ADDENDUM NO. 3 TO PLANS AND CONTRACT DOCUMENTS
FOR
GRAND LIARD MARSH AND RIDGE RESTORATION
(BA-68)
PLAQUEMINES PARISH, LOUISIANA

STATE OF LOUISIANA
COASTAL PROTECTION AND RESTORATION
AUTHORITY

JANUARY 15, 2014

GRAND LIARD MARSH AND RIDGE RESTORATION		MARSH CREATION AREA LAYOUT
STATE PROJECT NUMBER: BA-68	DATE: OCTOBER 2013	
FEDERAL PROJECT NUMBER: BA-68	APPROVED BY: RUDOLPH SIMONEAUX, P.E.	SHEET 5 OF 54

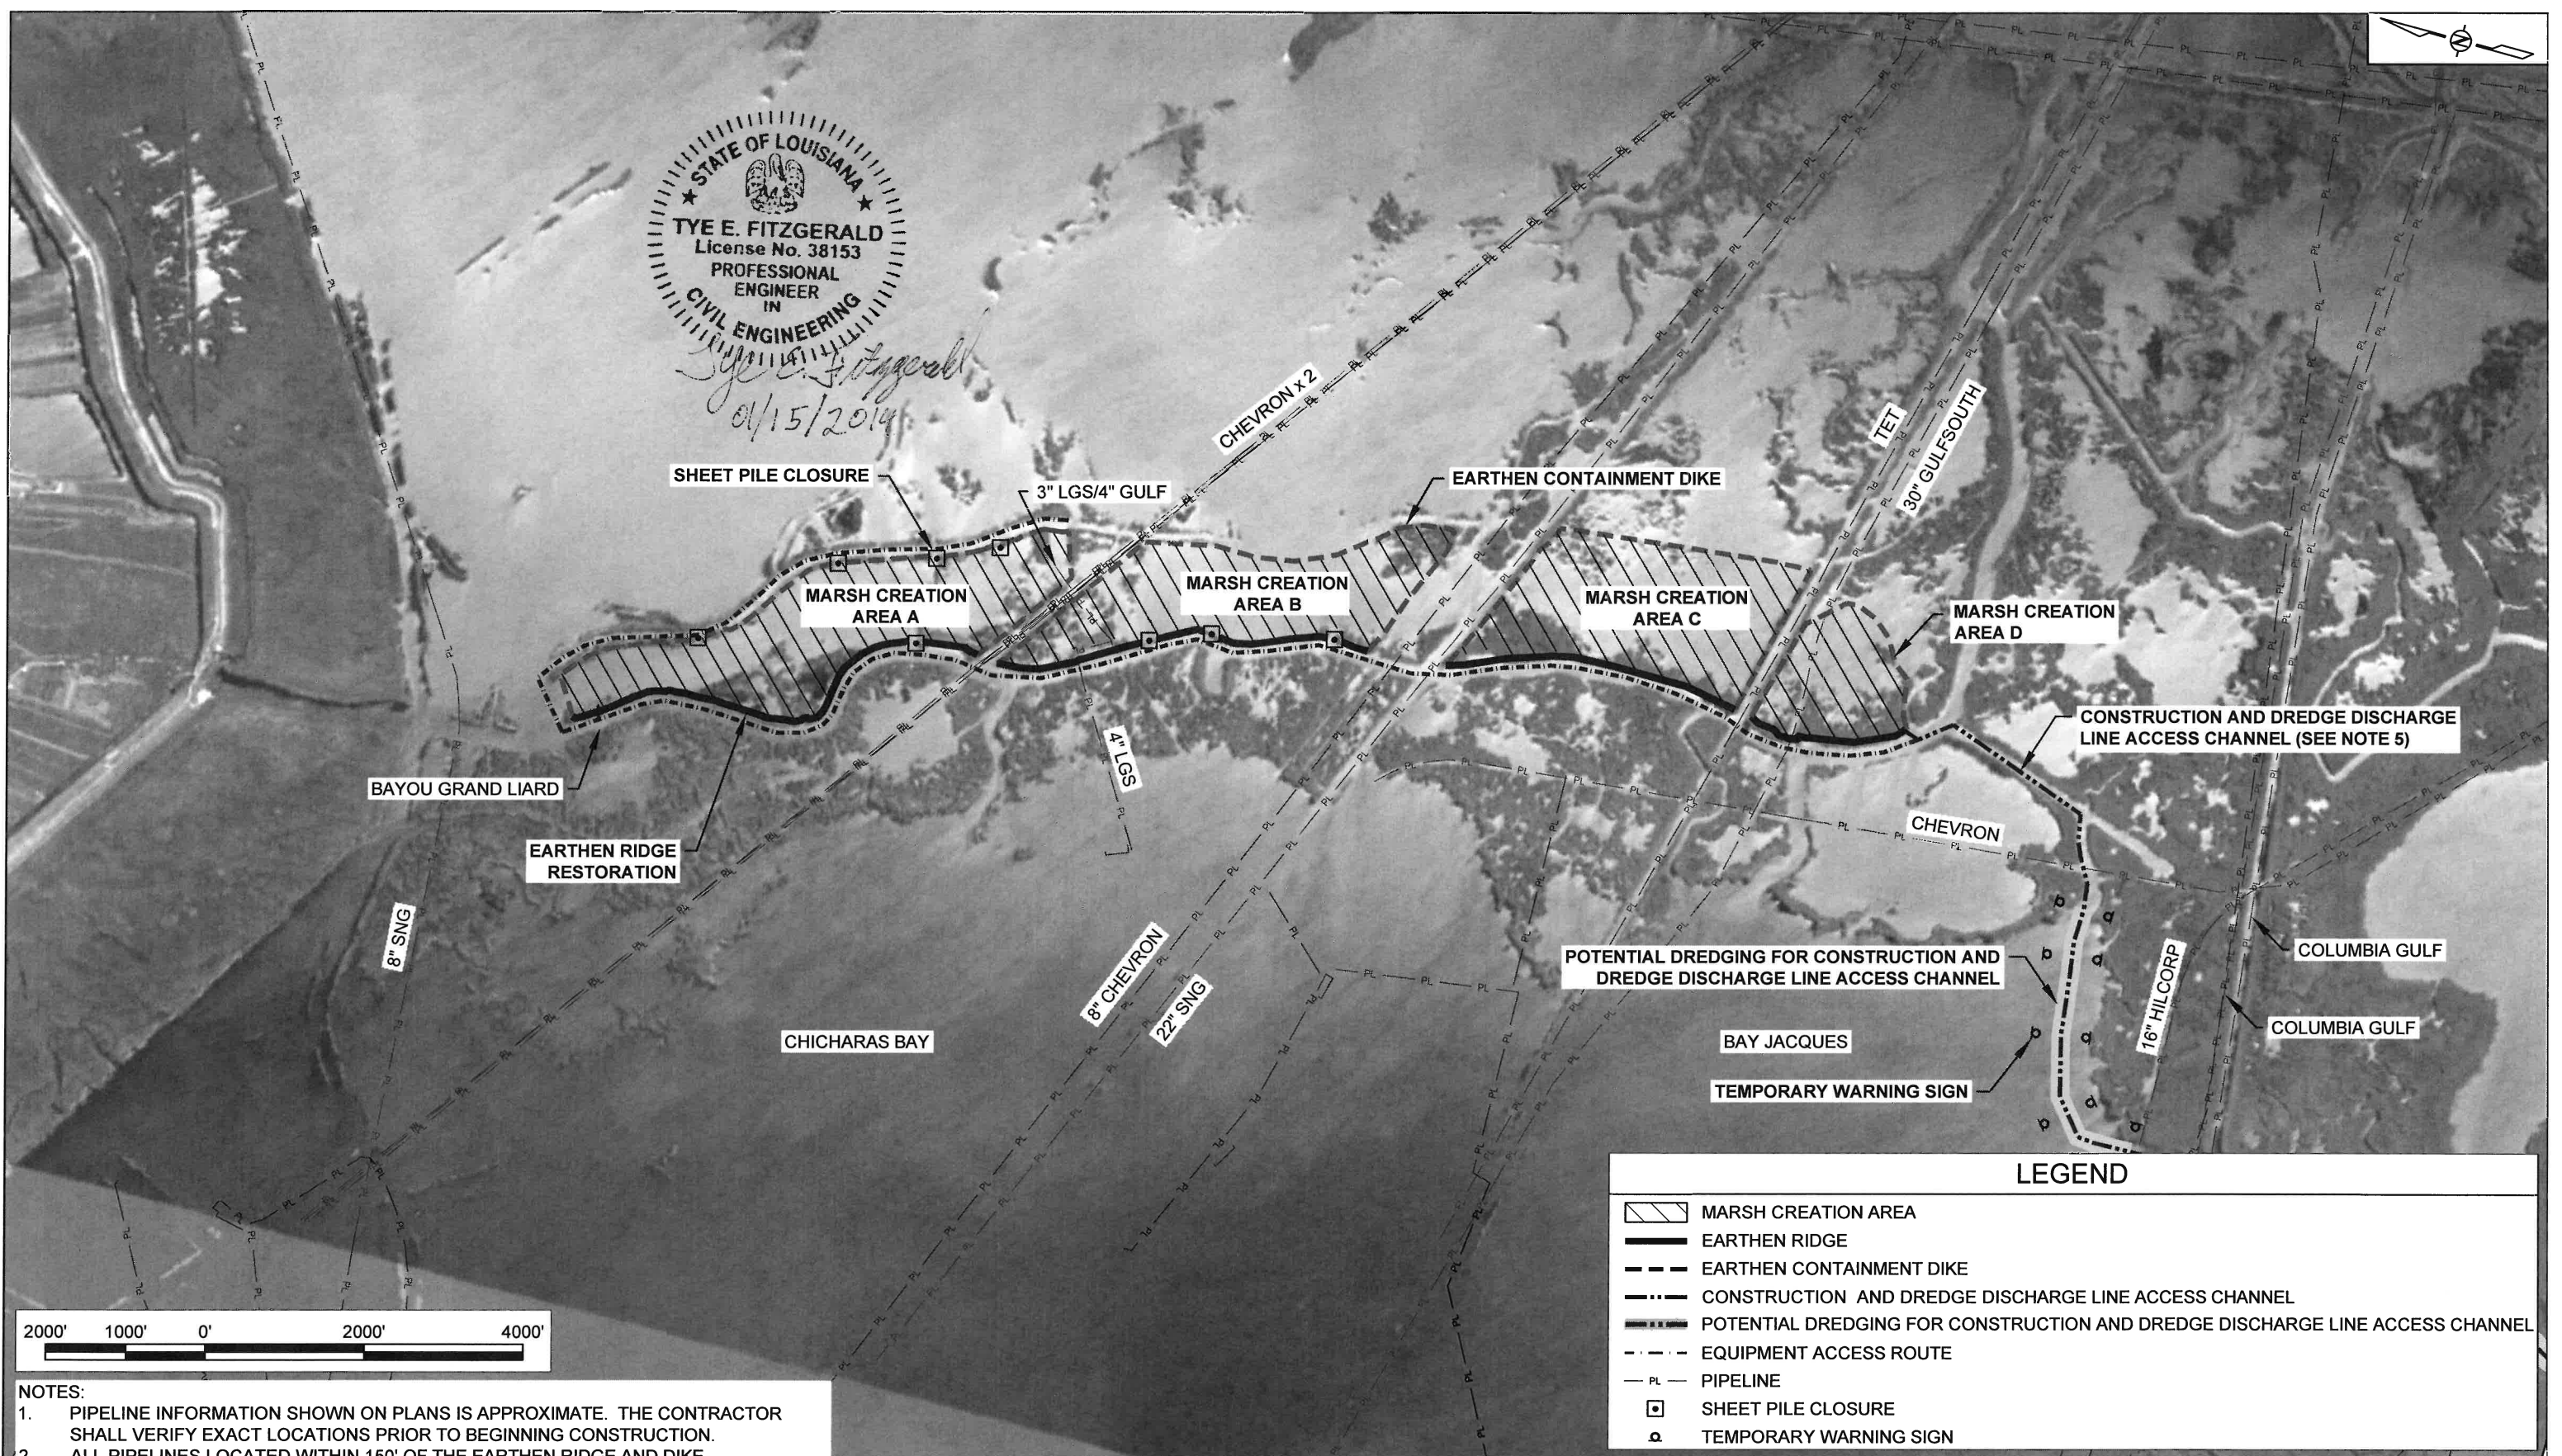
1. **Sheet 5 of 54:**

- a. Revised 2” GULF pipeline callout in Marsh Creation Areas A and B to:

“3” LGS/4” GULF”

- b. Removed erroneous 2” LGS callout in Marsh Creation Area B.

REV.	DATE	DESCRIPTION	BY
1	1/9/2014	REMOVED ERRONEOUS 2" LGS CALLOUT IN MARSH CREATION AREA B.	KC
2	1/9/2014	REVISED 2" GULF CALLOUT TO 3" LGS/4" GULF FOR PIPELINE IN MARSH CREATION AREAS A & B.	KC

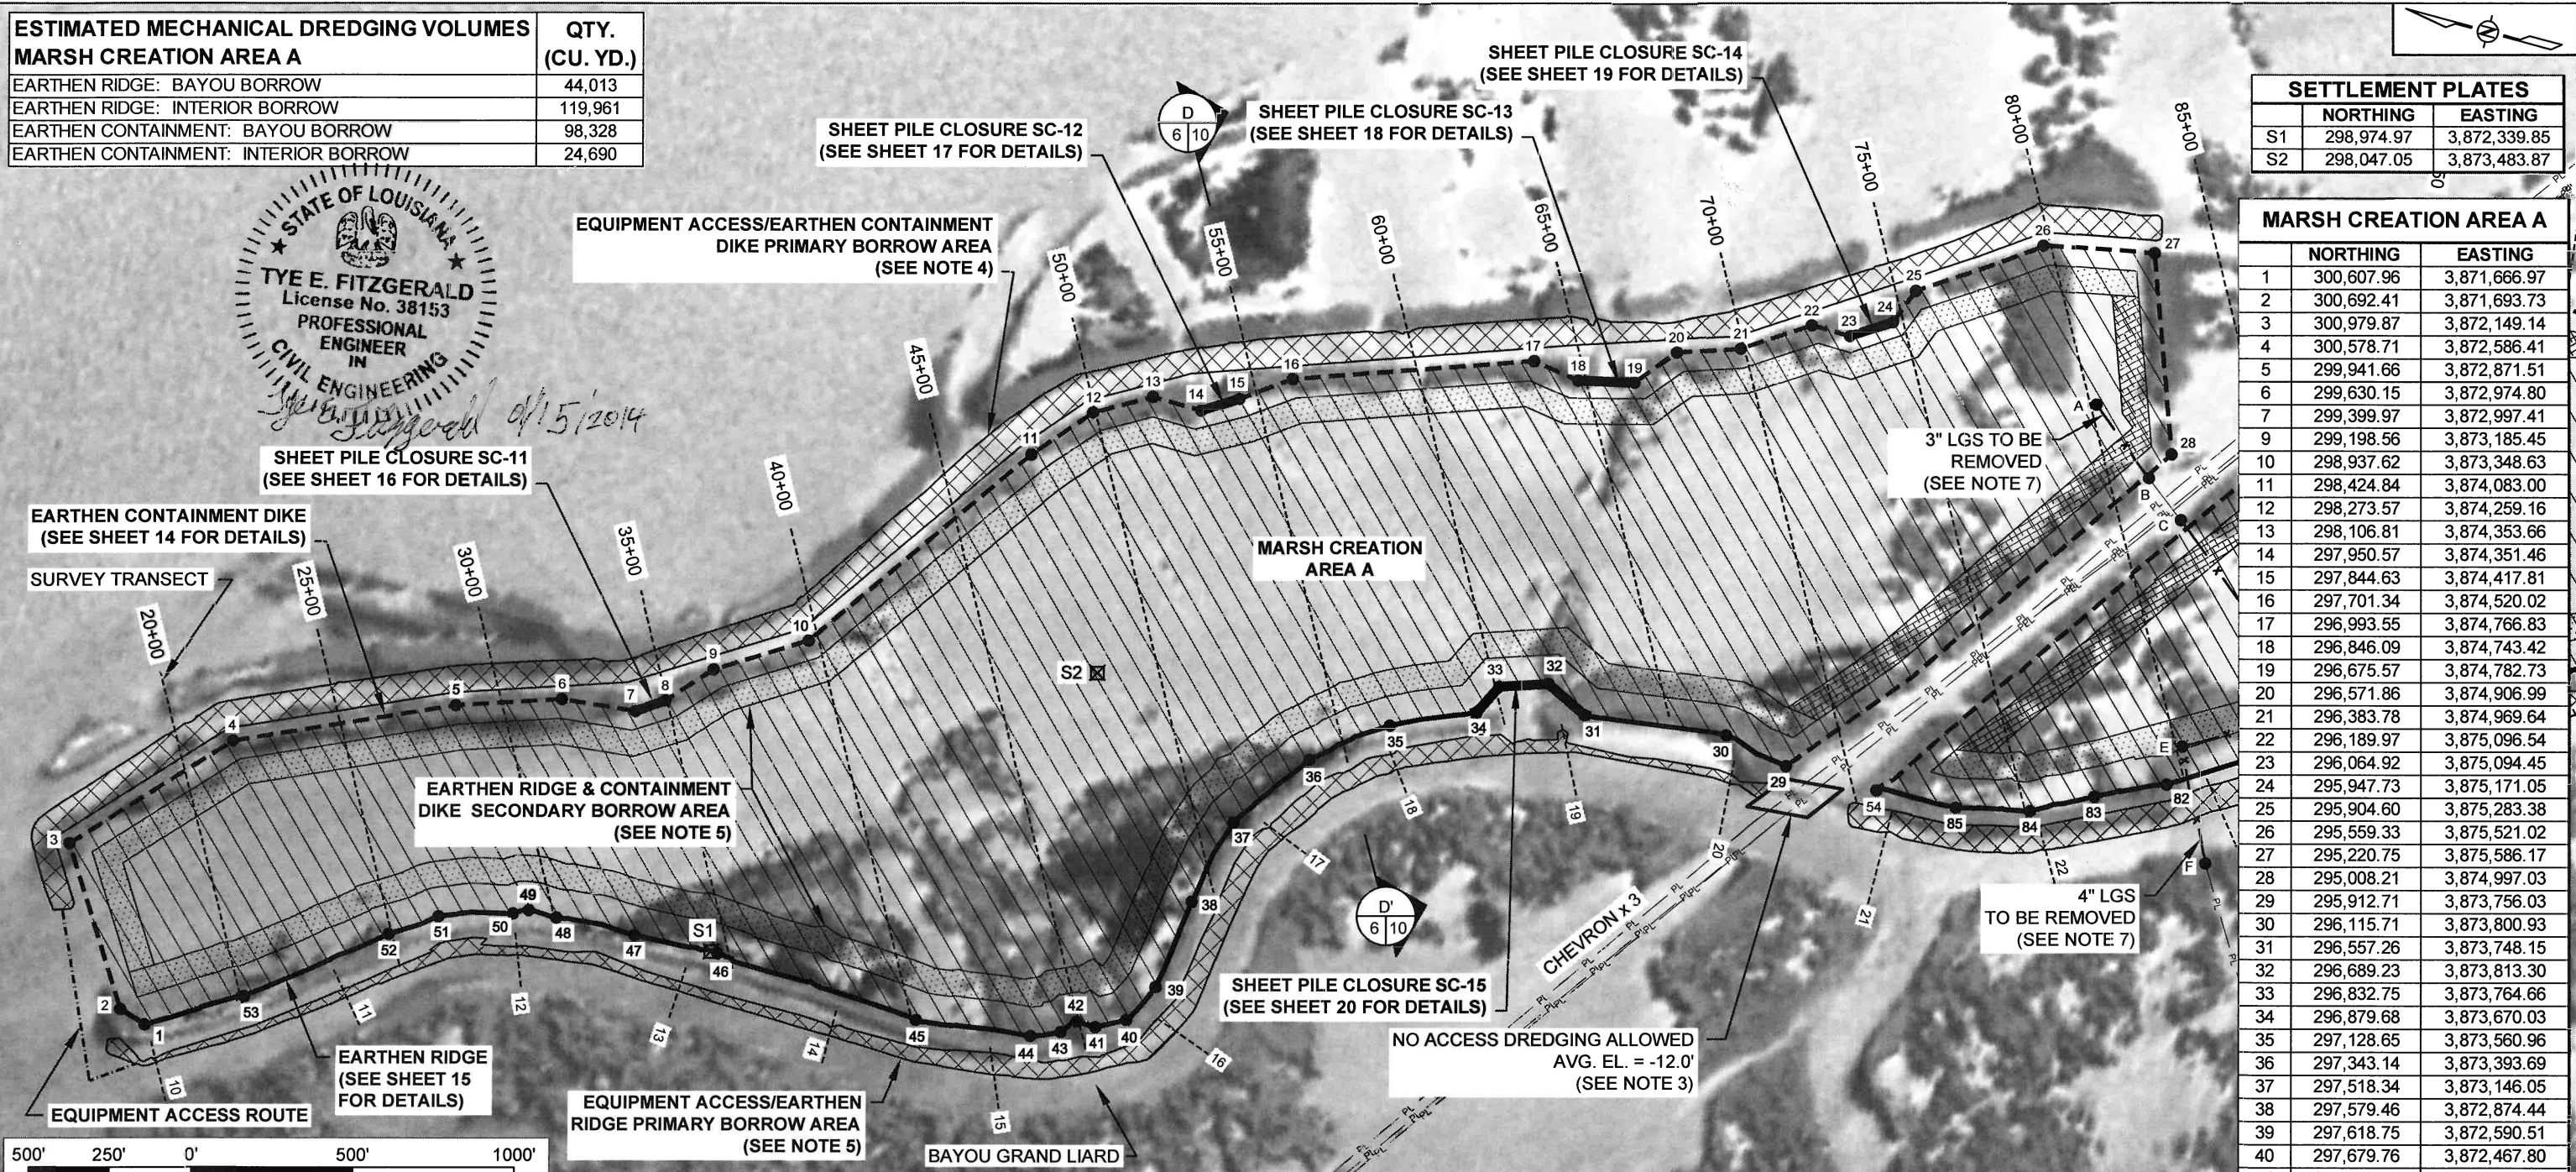
2. Sheet 6 of 54:

- a. Removed erroneous 2” LGS callout in Marsh Creation Area B.
- b. Revised 2” GULF pipeline callout in Marsh Creation Areas A to:

“3” LGS”

- c. Note 7 was revised to:

“THE 3” AND 4” LOUISIANA STATE GAS CORPORATION PIPELINES SHALL BE CUT AND REMOVED BY THE CONTRACTOR. SEE TS-3 OF THE SPECIFICATIONS AND SHEET 7 FOR MORE DETAILS.”

REV.	DATE	DESCRIPTION	BY
1	1/9/2014	REMOVED ERRONEOUS 2" LGS CALLOUT IN MARSH CREATION AREA B.	KC
2	1/9/2014	REVISED PIPELINE REMOVAL CALLOUT SHOWN IN MC AREA A. 2" GULF WAS REVISED TO 3" LGS.	KC
3	1/9/2014	2" GULF SOUTH WAS REVISED TO 3" & 4" LOUISIANA STATE GAS CORPORATION IN NOTE 7.	KC

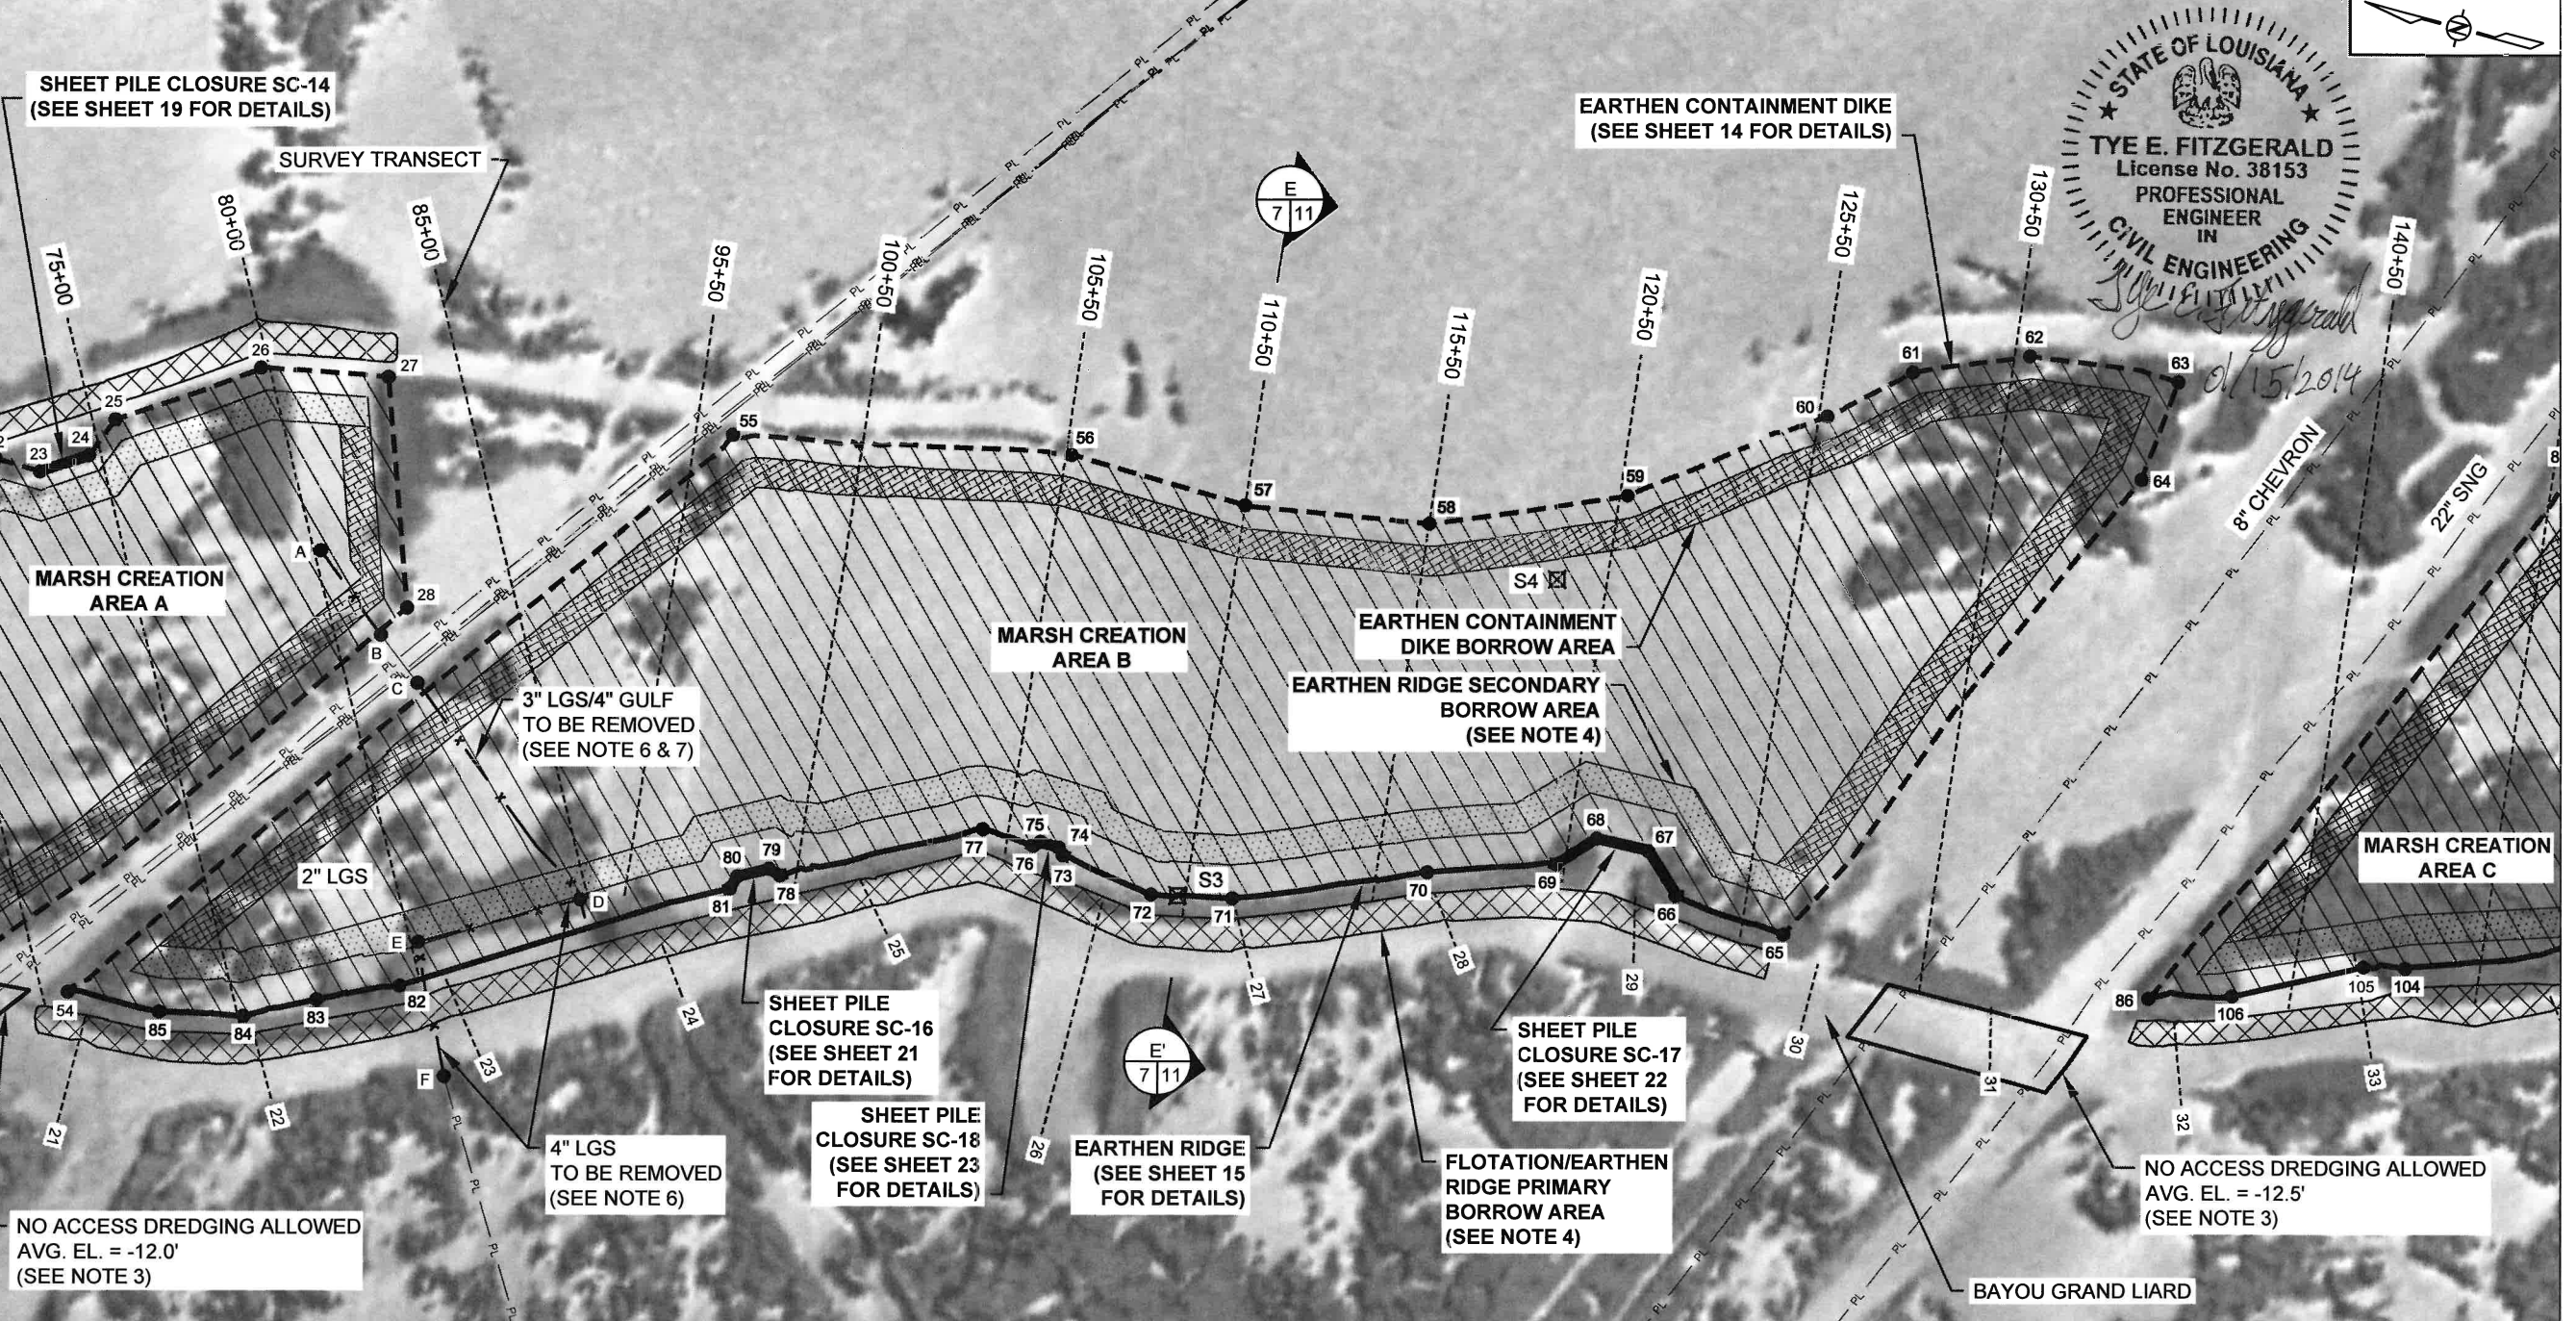
Contractor Question/Comment (25): Specification Section TS-3, Pipeline Removal, paragraphs 3.1 and 3.2, mention the removal of approximately 3,400 feet of pipeline; however, the distances between the points listed on plan sheet 7 and associated C.U.P.s total about 2,500 feet. Is the Contractor required to remove quantity listed in TS-3, 3.2, or only the portions between the points on plan sheet 7?

Contractor Question/Comment (26): Are the pipeline segments entering the Chevron pipeline corridor, between points B and C on plan sheet 7, to be removed or will they be capped and remain in-place, at point B and point C?

Contractor Question/Comment (27): Specification Section TS-3, Pipeline Removal, paragraphs 3.2, permit no. P19841123 and plan sheet 7 indicate a 2" pipeline; however, our research of C.U.P. P841123 documents only indicate a 3" pipeline. What is the correct diameter of the pipeline?

3. Sheet 7 of 54:

- a. Revised 2” GULF pipeline callout in Marsh Creation Areas B to:

“3” LGS/4” GULF TO BE REMOVED (SEE NOTES 6 AND 7)”

- b. Note 6 was revised to:

“THE 3” AND 4” LOUISIANA STATE GAS CORPORATION PIPELINES SHALL BE CUT AND REMOVED BY THE CONTRACTOR. SEE TS-3 OF THE SPECIFICATIONS FOR MORE DETAILS.”

- c. Note 7 was add:

“THE 4” GULF SOUTH PIPELINE SHALL BE CUT AND REMOVED BETWEEN POINTS C AND D BY THE CONTRACTOR. SEE TS-3 OF THE SPECIFICATIONS FOR MORE DETAILS.”

CPRA Response (25): There are two pipelines located between points C and D. The Contractor is only required to remove the pipelines between the points listed on Plan Sheet 7 (A-B and C-D-E-F). Pipeline sections between points B-C shall be flushed, capped, and remain in-place.

CPRA Response (27): Per Permit No. P19841123, the correct diameter is 3". See Revisions to Specifications.

REV.	DATE	DESCRIPTION	BY
1	1/9/2014	REVISED PIPELINE REMOVAL CALLOUT SHOWN IN MC AREA B. 2" GULF WAS REVISED TO 3" LGS/4" GULF.	KC
2	1/9/2014	2" GULF SOUTH WAS REVISED TO 3" & 4" LOUISIANA STATE GAS CORPORATION IN NOTE 6.	KC
3	1/9/2014	NOTE 7 WAS ADDED.	KC
